UNITED STATES PATENT AND TRADEMARK OFFICE

APPLICATION NO.	FILING DATE	FIRST NAMED INVENTOR	ATTORNEY DOCKET NO.	CONFIRMATION NO.
10/719,786	11/21/2003	Edward Paul Carlin	9431	2939

Office Action Summary	Application No. 10/719,786	Applicant(s) CARLIN, EDWARD PAUL	
	Examiner Michael G. Bogart	Art Unit 3761

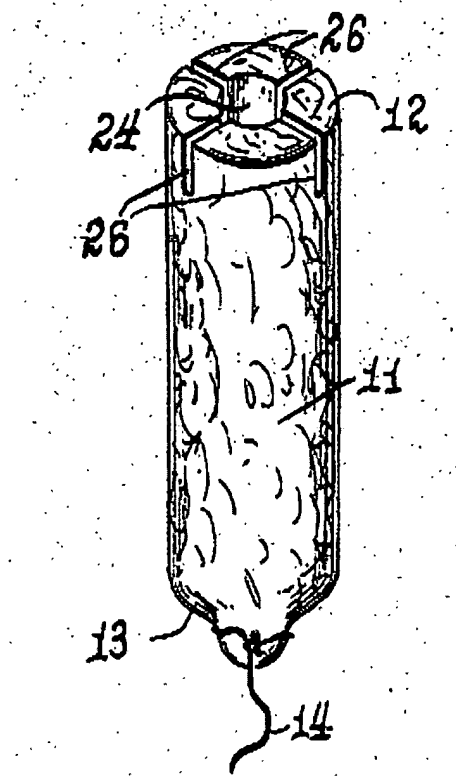
Regarding claims 2 and 13, Glassman teaches a tampon (11) for feminine hygiene comprising an insertion end (12), a withdrawal end (13), a length, a longitudinal axis, a radial axis, and an outer surface;

said tampon (11) being comprised of compressed fibrous material (col. 2, lines 25-49);

wherein a measured portion of said outer surface of said insertion end (12) comprises a first surface area and a measured portion of said outer surface of said withdrawal end (13) comprises a second surface area, said first surface area being different than said second surface area, wherein at least a portion of said first surface area comprises grooves (26), wherein said grooves (26) are selected from the group consisting of longitudinal grooves, horizontal grooves and mixtures thereof (see fig. 1, below).

Glassman is silent as to the specific length of the grooves (26).

Mere changes in relative size or proportion are not sufficient to patentably distinguish a claimed invention from the prior art. In *Gardner v. TEC Systems, Inc.*, 725 F.2d 1338, 220 USPQ 777 (Fed. Cir. 1984), *cert. denied*, 469 U.S. 830, 225 USPQ 232 (1984), the Federal Circuit held that, where the only difference between the prior art and the claims was a recitation of relative dimensions of the claimed device and a device having the claimed relative dimensions would not perform differently than the prior art device, the claimed device was not patentably distinct from the prior art device. MPEP § 2144.04.

Regarding claims 9-11 and 14, Glassman teaches grooves (26) arranged in a radial pattern of evenly spaced longitudinal straight lines (fig. 1).

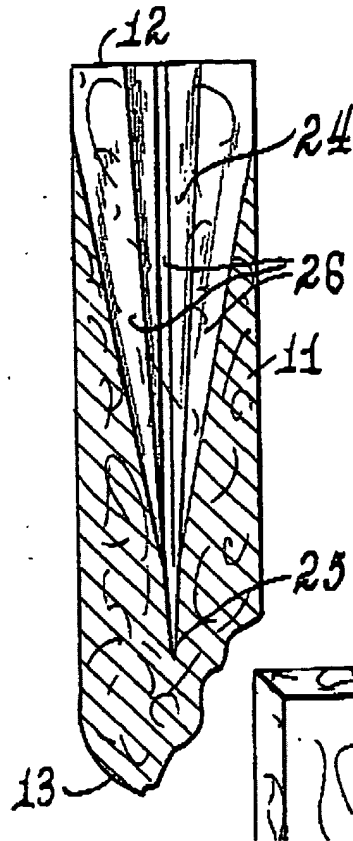
Regarding claims 18 and 19, Glassman teaches that at least at the withdrawal end (13) that the compressed fibrous material is of essentially uniform density (col. 2, lines 25-49)(see fig. 2, below).
